**ADDENDUM NO. ONE TO  
SYSTEM INVENTORY AND  
ASSESSMENT STUDY FOR  
COLORADO SPRINGS  
UTILITIES WATER SYSTEM  
CONVERSION**

**CASCADE METROPOLITAN  
DISTRICT NO. 1**

PROJECT NO. 15061.100

March 9, 2016

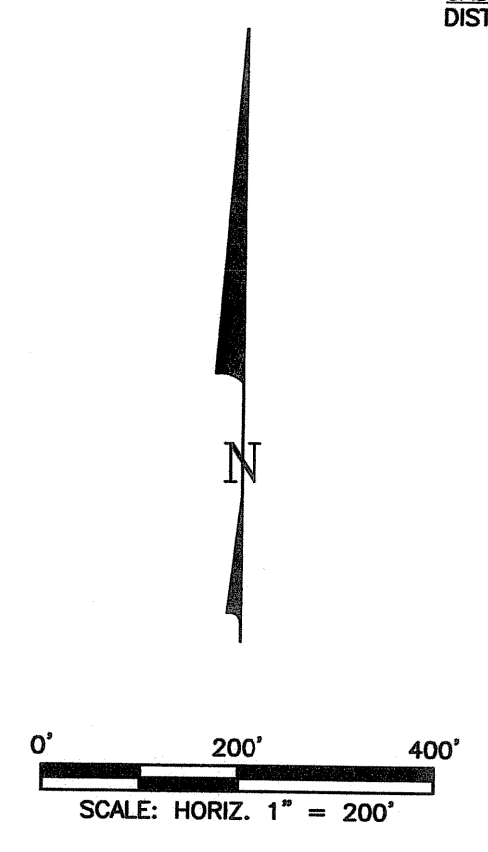
- #32 - Tank site. Need a grant of formal Access to the tank site from the property owner. Have no information about the existing two-track. **[Need Access Easement from Pyramid Mtn Rd to the Tank Site Property.]**

**Response:** We acknowledge the existing two tracks may not follow the existing easement. If it is determined the tank site will remain in place and the Inflow and Outflow easements are required, we recommend the existing lines be located in accordance with comment number 31. A new easement will be prepared 30-feet in width with an access road constructed over the existing pipeline corridor thus eliminating the need for a separate access easement. Constructing the access road over the pipeline will enhance access to the water main for operation and maintenance responsibilities.
